NUMBER: 07-002-14

GROUP: Cooling

Coolant Weepage At EGR Hose

This bulletin involves replacing the EGR hose.

Fig. 1 EGR

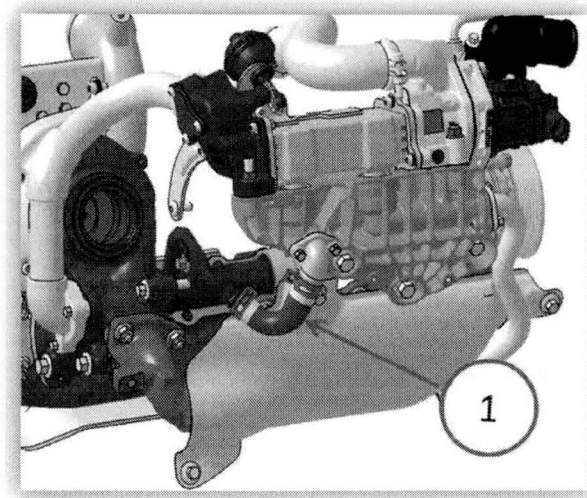
The EGR hose may weep coolant.

Qty.	Part No.	Description
(1)	**68253365AA**	EGR Coolant Hose

2. Lower the belly pan splash shield.
3. Lower the rear transmission splash shield.
4. Replace the EGR coolant hose.
